**ABU GHRAIB DAIRY
ABU GHRAIB, IRAQ**

**SIGIR PA-09-172
JANUARY 14, 2009**

Summary of Report: PA-09-172

Figure 2. Primary truss configuration

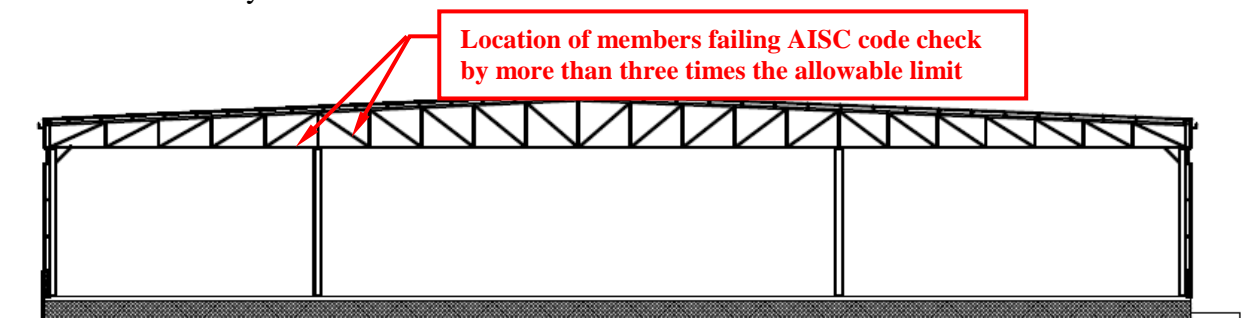
- Based on the contractor's calculations, five members of the truss were designated as failing the AISC code check. Two of the members failed the code check by more than three times the allowable limit (Figure 2). Failing by a factor of this magnitude indicates that the members could yield and possibly fracture under the design load.

The contractor's proposed structural design consists of steel columns and continuous truss construction with sandwich panel cladding¹⁸ for the roof and sidewalls. Roof loads are carried by the multi-span steel trusses, which have two configurations. The primary configuration has steel columns supporting the truss at the ends and at approximately one-third span (Figure 2). The columns are centered on a truss panel point (the location of intersecting truss members), which is appropriate. Based upon the contractor's drawings, it appears that the member sizes have been modified to accommodate the stress reversal¹⁹ over only one of the interior columns.

Figure 3. Truss configuration at mezzanine level

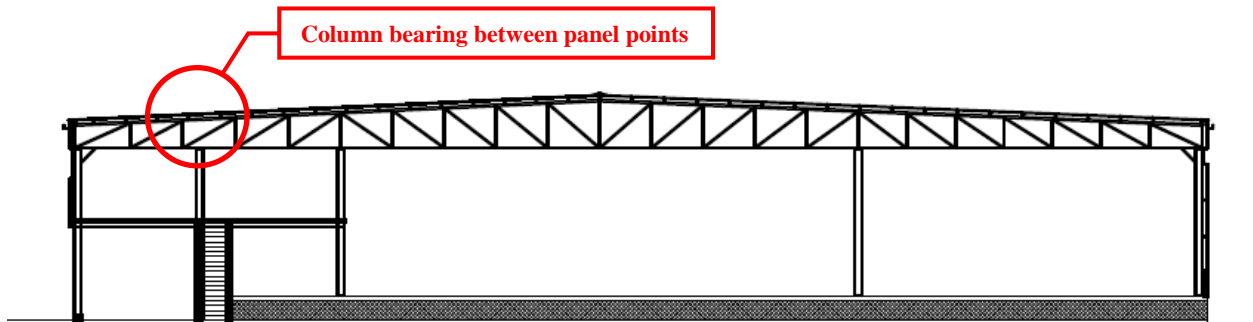
In the area of the mezzanine, the plans show additional columns (Figure 3), which extend through the mezzanine to the underside of the truss. The additional bearing locations provided by these columns are not at a truss panel point. The resulting reactions from these columns will introduce bending into the lower chord of the truss. SIGIR is

concerned that the members used in the lower chord of the truss are relatively light and do not appear to have the capacity to resist a significant amount of bending stress in addition to the compressive load that will result from the intermediate support.

Figure 4. Knee brace detail

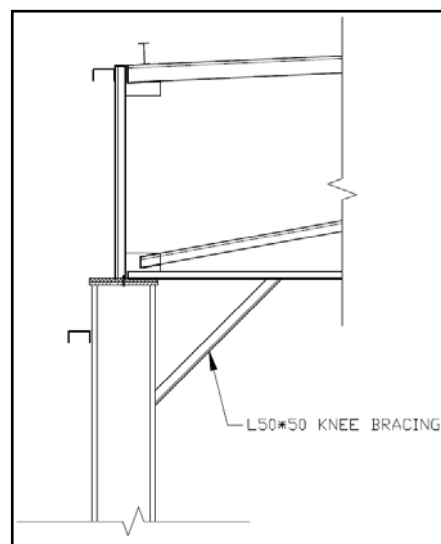
The contractor's design drawings do not address the method used to resist lateral loads parallel to the building's gable. It appears that the design incorporates diagonal cross bracing between several bays in the direction parallel to the ridge; however, there is no indication of bracing parallel to the gable (slope). In addition, the building's use of column and truss construction requires additional consideration of lateral loads. The only members that appear to be placed to provide lateral stability in the axis of the gable are the diagonal knee braces (Figure 4). These knees appear to be severely undersized, considering their location and configuration.

If the braces are used to resist lateral loads, the connection between the columns and truss would become, at least, partially fixed. This would introduce significant load into the lower chord of the truss, which appears to be already undersized. Fixing the truss/column connection would also introduce a lateral component into the column reaction; special consideration would then be required in the design of the foundation to resist this load.

Site Photo 1. Typical foundation pedestal and anchor bolts

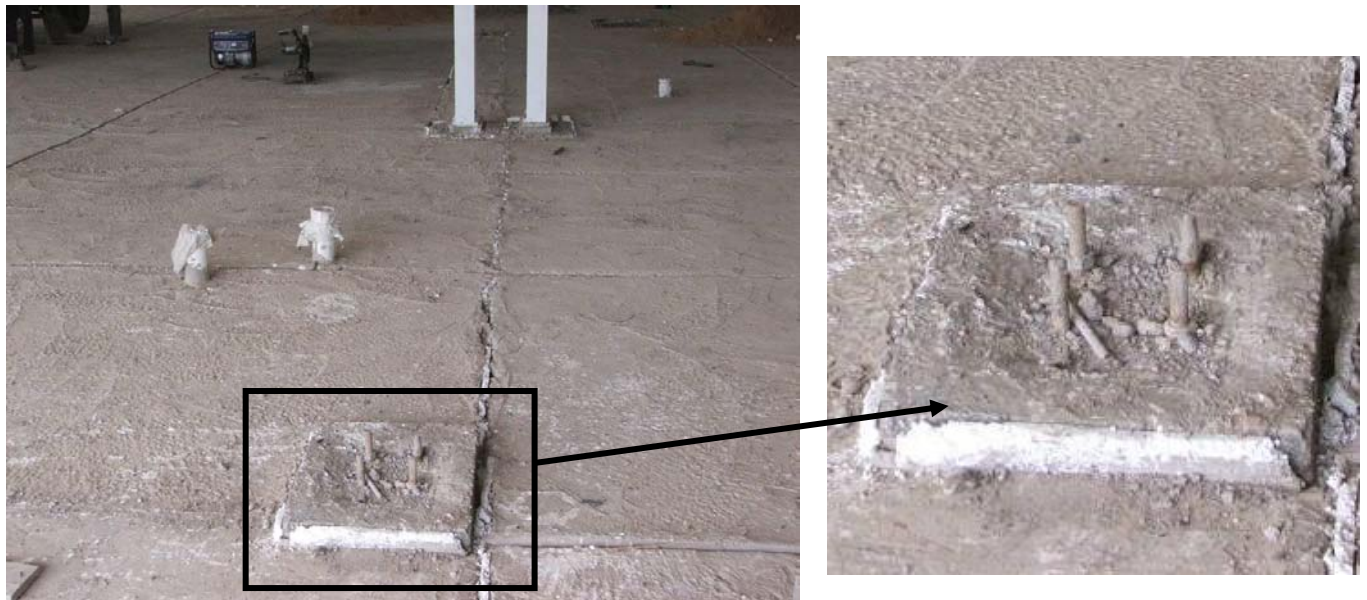
At the time of the site visit, the foundations for the facility were installed. The foundation system appeared to be concrete pedestals with steel anchor bolts attached to the base plates of the steel columns (Site Photo 1). The foundation system also included spread footings to support the concrete pedestals and columns. Since the foundation was in the later stages of construction, only the upper portion of the foundation was exposed for inspection; consequently, SIGIR could not verify the construction of the foundation.

Site Photo 4. Cross brace conflict with CMU perimeter wall

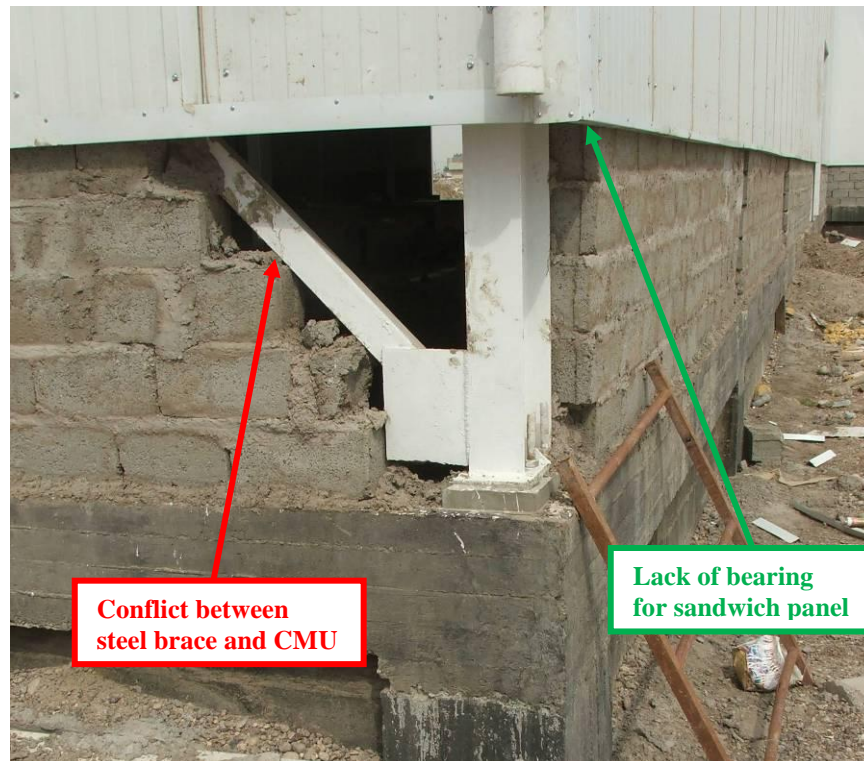
The CMU wall interferes with the steel cross bracing between several of the columns (Site Photo 4). It appears as if the contractor's solution to this issue was to lay the CMU wall around the bracing and coat the entire area with plaster. However, this approach may cause future problems as the steel bracing moves independently of the CMU wall causing recurrent cracking at the location.

Previously, SIGIR noted that due to the contractor's deviation from the design drawings, the steel cross bracing for the structure conflicted with the CMU perimeter wall. To correct this, the contractor removed the CMU wall, relocated the steel cross bracing to the interior of the wall, and reconstructed the wall (Site Photos 19 and 20).

Site Photo 5. Course of CMUs placed with cores horizontal

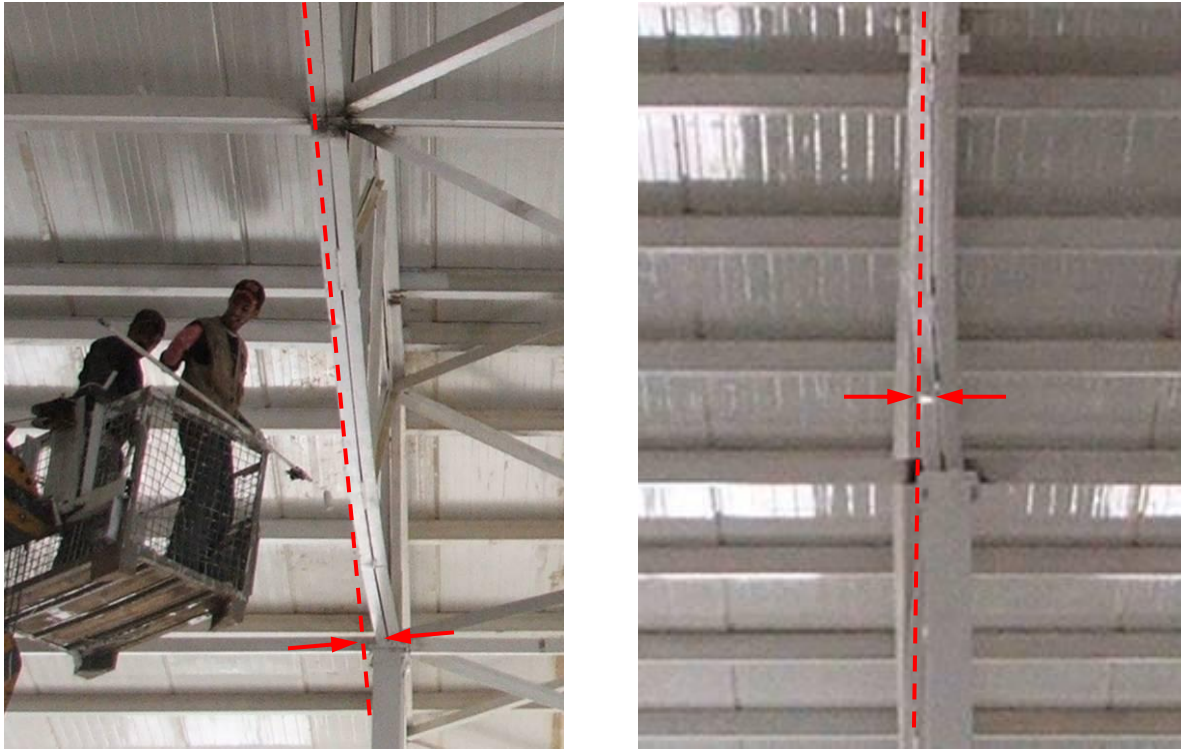
SIGIR also noticed several areas where one course of CMUs was laid on their sides (cores horizontal) (Site Photo 5). The detailed plans did not show this type of construction technique and it is unclear why the contractor did this. SIGIR's concern is that CMUs are significantly weaker when placed in this orientation. If these CMUs are intended to support the weight of the loaded floor slab, additional reinforcement of this area is needed.

Site Photo 18. Contractor's truss modification

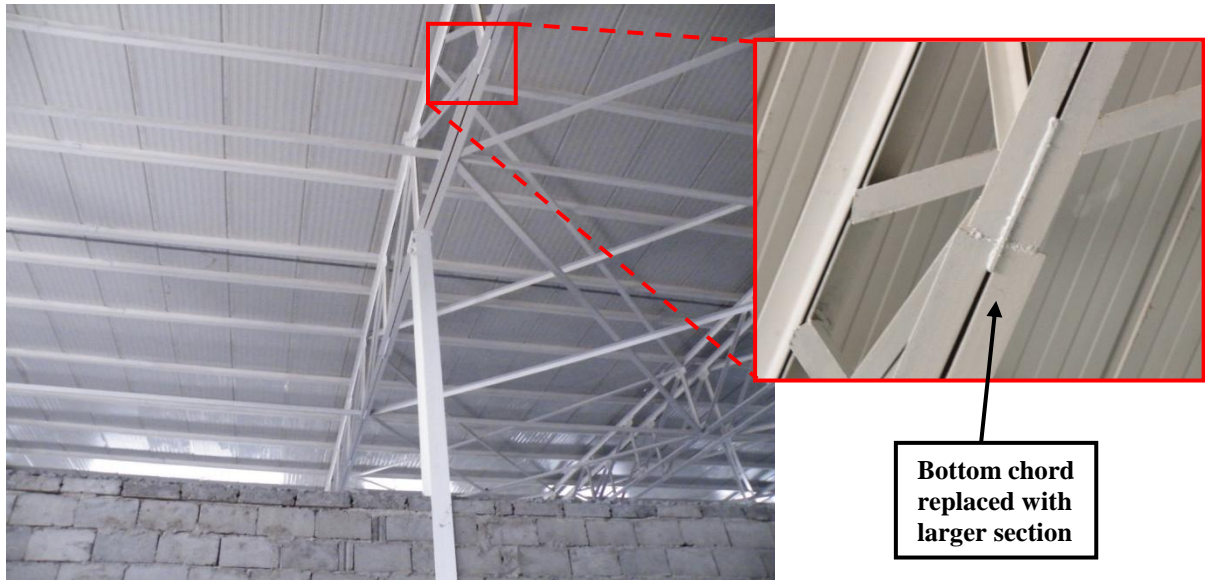
In order to remedy the deformation of the roof trusses SIGIR previously identified, the contractor's modification included the removal of the lower truss chord in the area where

it was inadequate and replaced it with a larger section. Aerial lift capabilities were not available at the time of the site visit; therefore, a hands-on inspection of the repair could not be made. However, SIGIR was able to verify that the trusses had a larger bottom chord section in the areas previously noted as deficient (Site Photo 18).
